**From:** LAllenby <[REDACTED]>  
**To:** "jeffrey E." <jeevacation@gmail.com>  
**Cc:** NYC - Richard Kahn <[REDACTED]>, "Allenby, Leighton" <[REDACTED]>  
**Subject:** Re: LSJ Plate Work  
**Date:** Mon, 03 Aug 2015 13:59:57 +0000

**From:** Leighton Allenby <[REDACTED]>  
**Date:** July 31, 2015 at 3:49:39 PM EDT  
**To:** Richard Kahn <[REDACTED]>  
**Subject:** Fwd: LSJ Plate Work

<resized2.jpg>

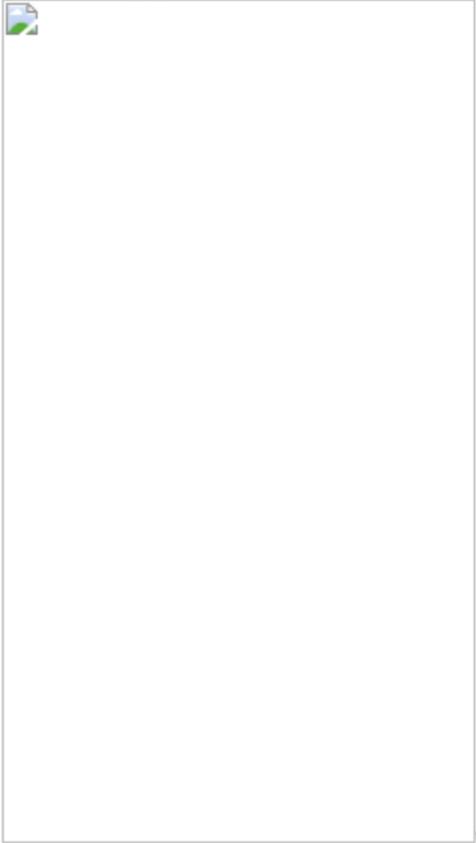
Good Morning Anna-

Upon reviewing and inspecting the inside of the compartments, forward of the engine room, we have come up with a quotation for repairing all the "wasted" plate. Approximately 160 square feet of plate has to be cut out and replaced. The square footage equals 848LBS x \$45 per pound the total would be \$38,160 (This price includes all labor and material). We will also have to remove both keel coolers due to their location with the plate that has to be cut out. We will also have to fabricate two new boxes in which they sit and then remount these boxes once the new plate is welded into place. The price for this is \$5850 includes labor and material. Two water tight bulkheads are also compromised and several areas will need to be "cropped" out and replaced. Labor and materials is \$3380. We will also "plug weld" 12 more additional areas that have deteriorated and need to be addressed. These two compartments have been inspected by both Gabriel, the project manager, and Bosco. In addition, the emergency bilge pump system needs to be renewed and it is our recommendation to have Bosco undertake this job. Please note that we have not charged any additional lay days and will continue not to. The areas that need to be cut out and replaced are very confined and difficult to work in. With the savings on lay days it is over \$3500 so we will not be able to move on our final quotation. I have also attached a few pictures.....

Total for labor and material.....\$47,390
